Plans Review
Municipality of Mississippi Mills
Building Dept.
2022-08-18

JOB:
PHOENIX HOMES
PNEWD-4
NEWINGTON 'D'
WTR-3 LOT 50
1st Floor Roof Framing

JOB:
PHOENIX HOMES
WHITE TAIL RIDGE
WTR3-50
NEWINGTON D
1ST FLOOR 1 OF 2

NEWINGTON – 2018

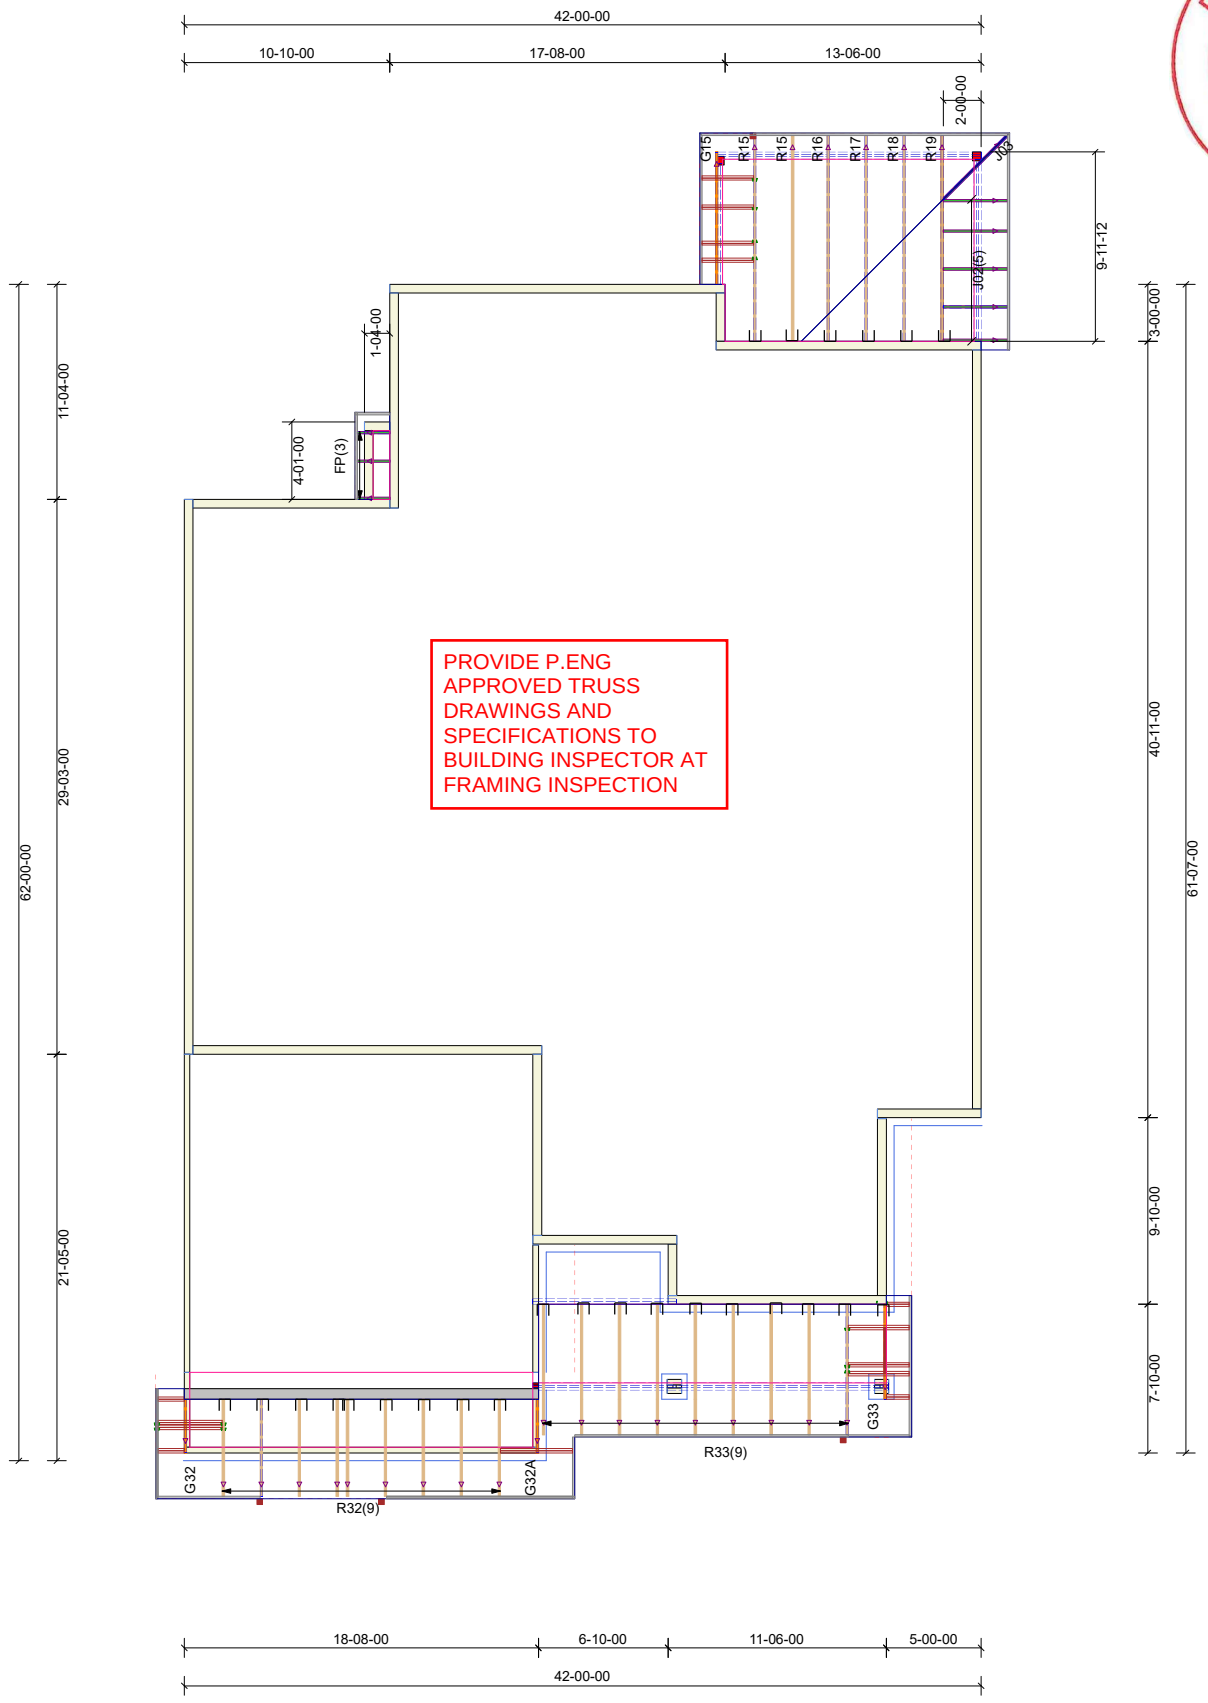
DETAILS SEALED BY A P.ENG ARE REQUIRED FOR THE LVL BEAMS ON FRAMING INSPECTION

PROVIDE P.ENG APPROVED FLOOR DRAWINGS AND SPECIFICATIONS TO BUILDING INSPECTOR AT FRAMING INSPECTION

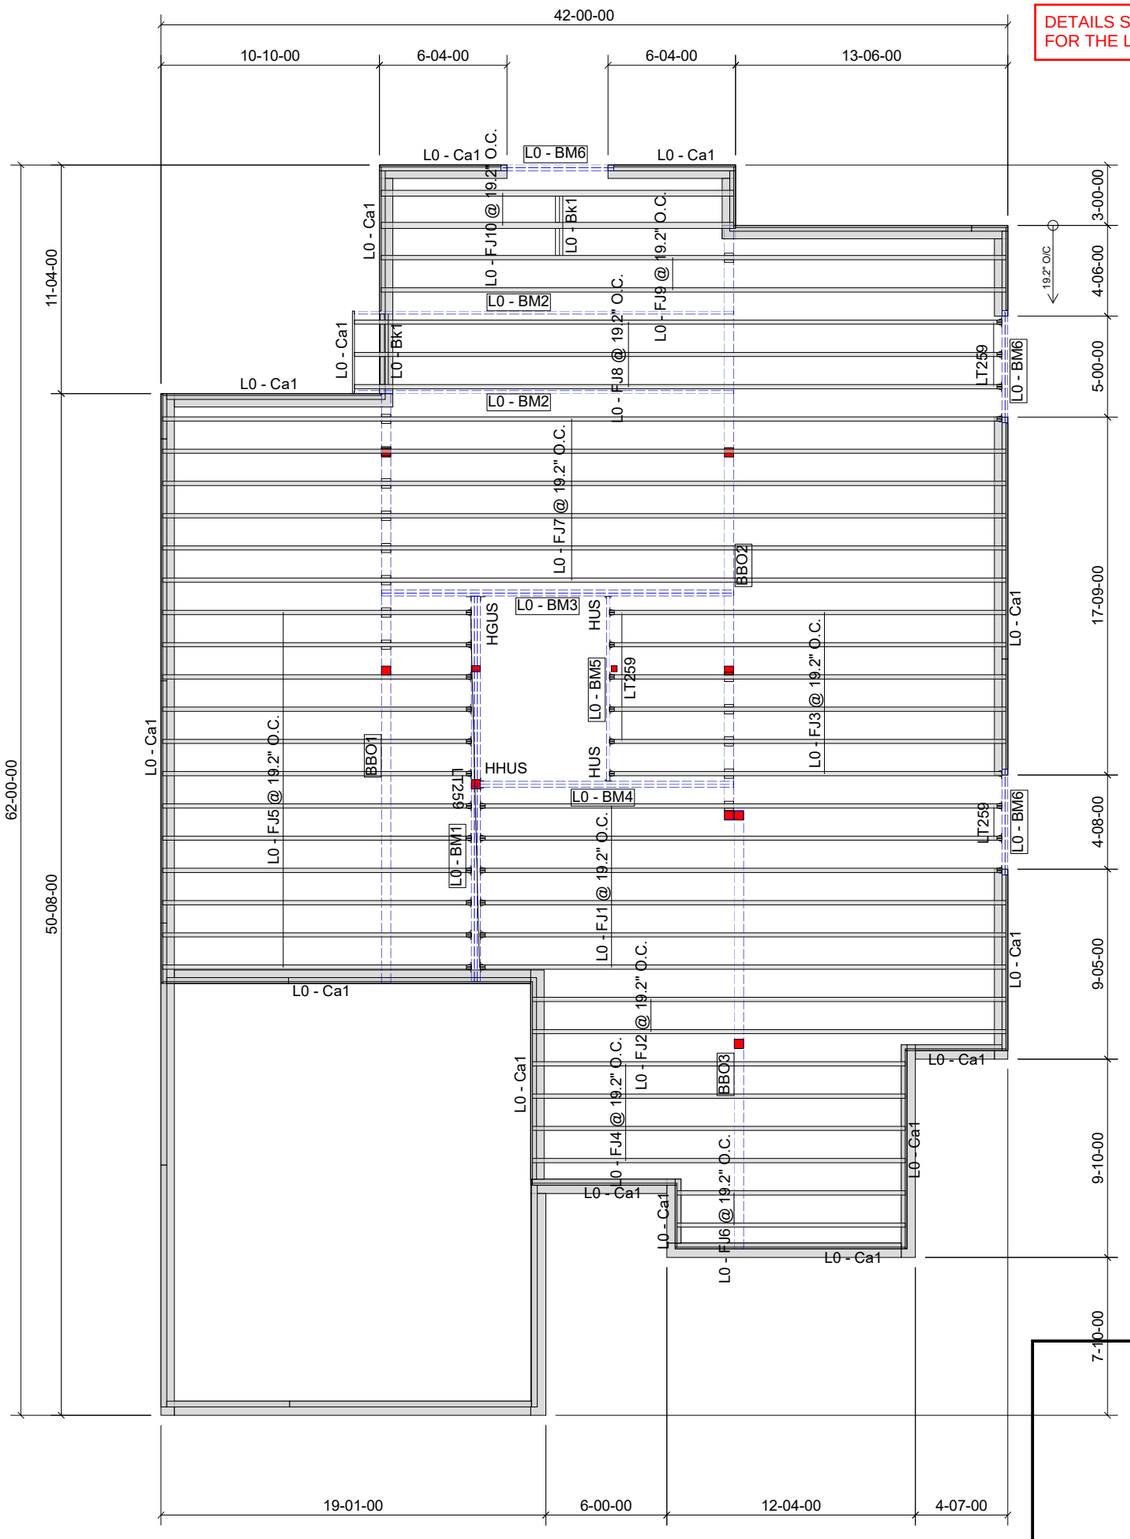
ANY OPENINGS IN FLOOR WEB FOR PLUMBING, HVAC AND ELECTRICAL TO MEET THE MANUFACTURER'S SPECS. P.ENG REPAIRS MAY BE REQUIRED IF HOLES ARE TOO LARGE, TOO CLOSE TOGETHER OR TOO CLOSE TO THE EDGES

PHOENIX HOMES
PNEWD-4
NEWINGTON 'D'
WTR-3 LOT 50
2nd Floor Roof Framing

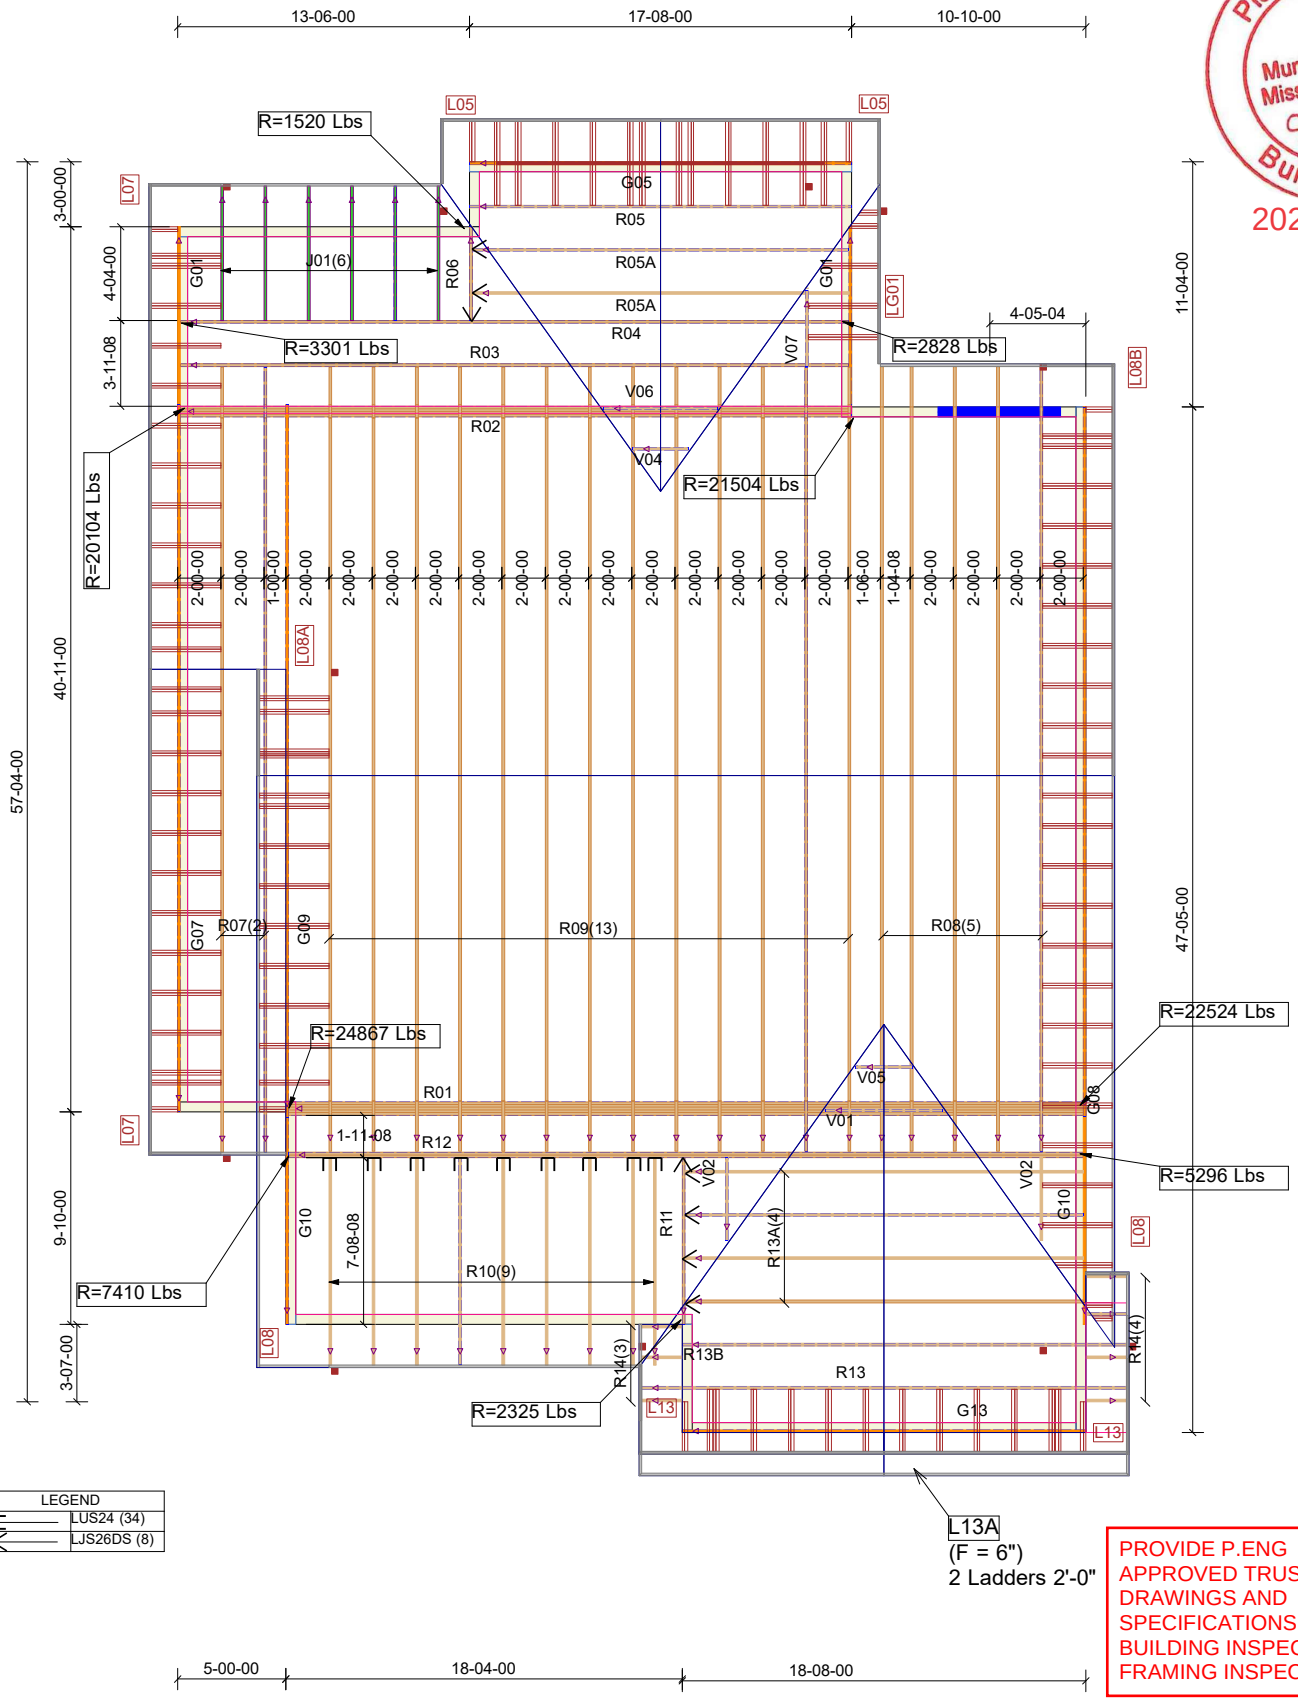
PROVIDE P.ENG APPROVED TRUSS DRAWINGS AND SPECIFICATIONS TO BUILDING INSPECTOR AT FRAMING INSPECTION

JOB:
PHOENIX HOMES
WHITE TAIL RIDGE
WTR3-50
NEWINGTON D
2ND FLOOR 2 OF 2

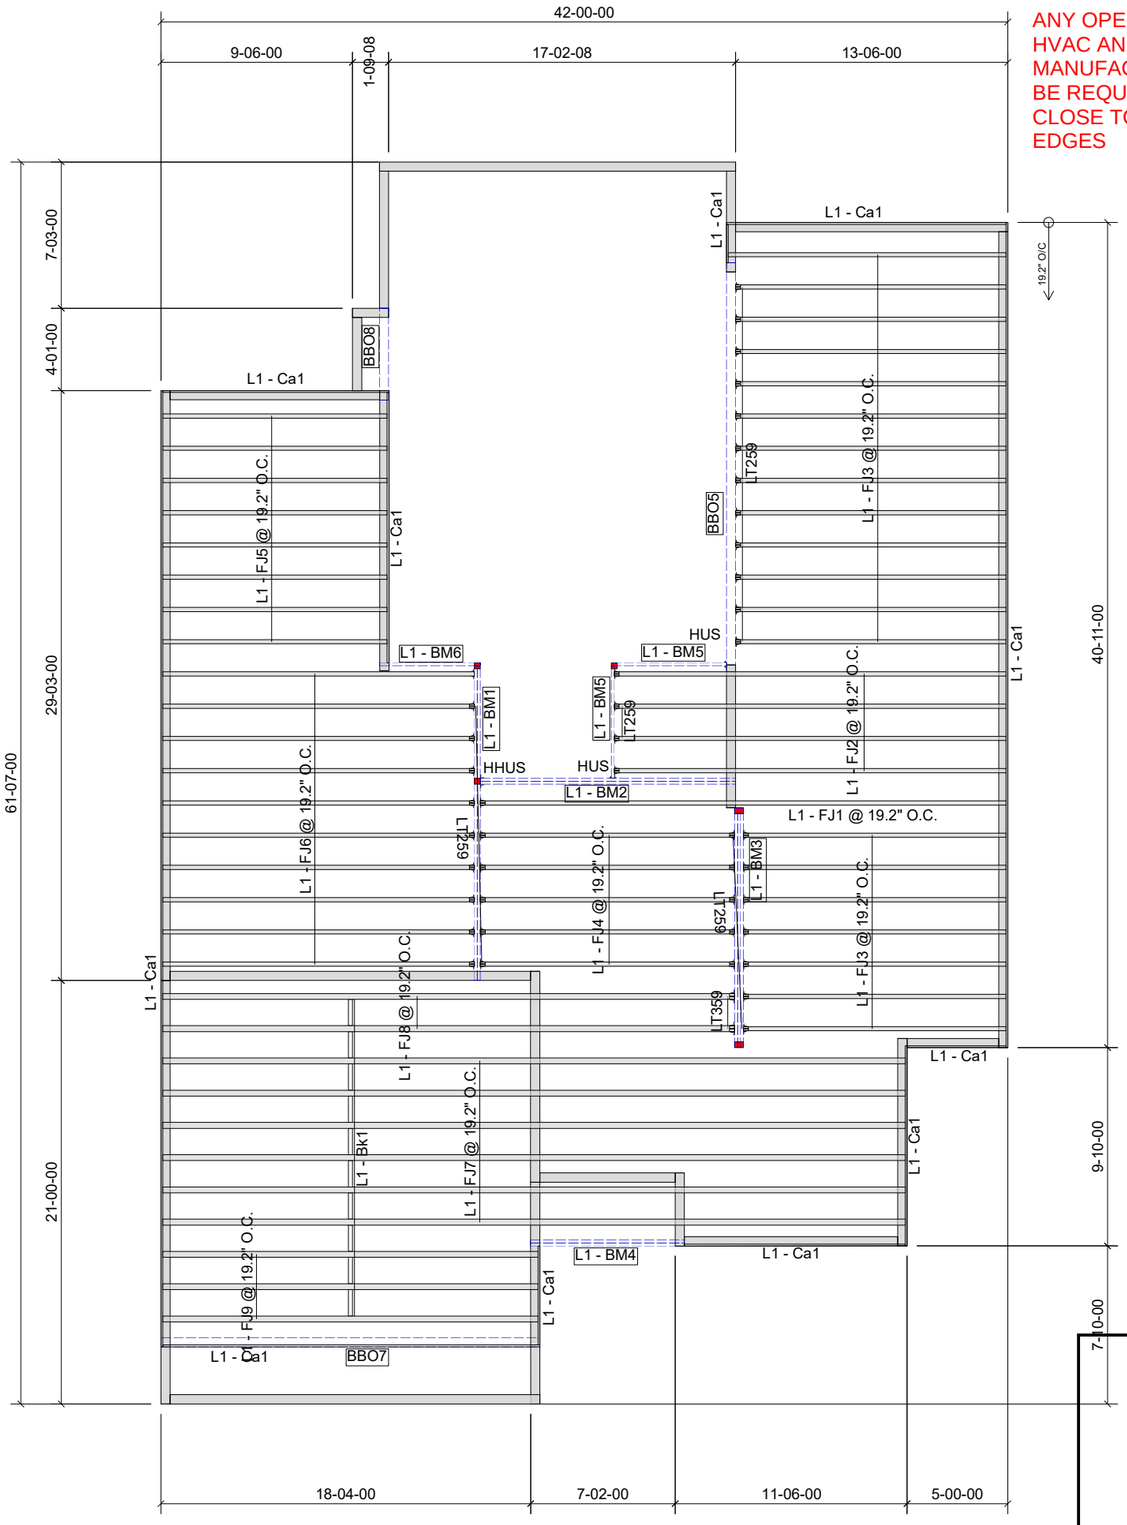
PROVIDE P.ENG APPROVED FLOOR DRAWINGS AND SPECIFICATIONS TO BUILDING INSPECTOR AT FRAMING INSPECTION

DETAILS SEALED BY A P.ENG ARE REQUIRED FOR THE LVL BEAMS ON FRAMING INSPECTION
